SERVICE BULLETIN

VFO-230

#838

SUBJECT: VFO-230 OPERATION ON 240V AC

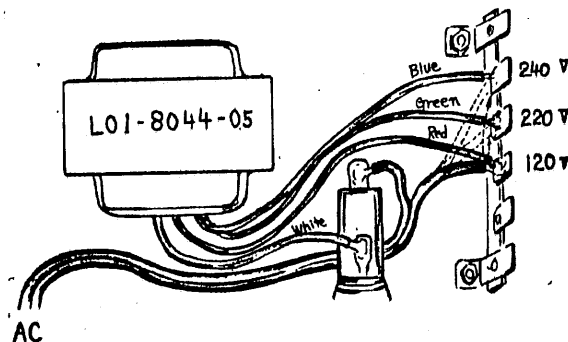
To operate the VFO-230 on 240V AC, the power transformer primary tap must be rewired from 120V to either the 220V or 240V tap.

1. Unplug the AC power cable and VFO interconnecting cable.
2. Remove the top cover.
3. Move the AC line from the 120V (Red) to either the 220V (Green) or 240V (Blue) transformer winding.
4. Change the AC fuse from 0.5A to 0.3A. Tag the power cord at the back of the unit to indicate that the transformer is wired for 240V AC, and the power fuse should be 0.3A and not 0.5A.
5. Replace the top cover and cable up to verify your work.
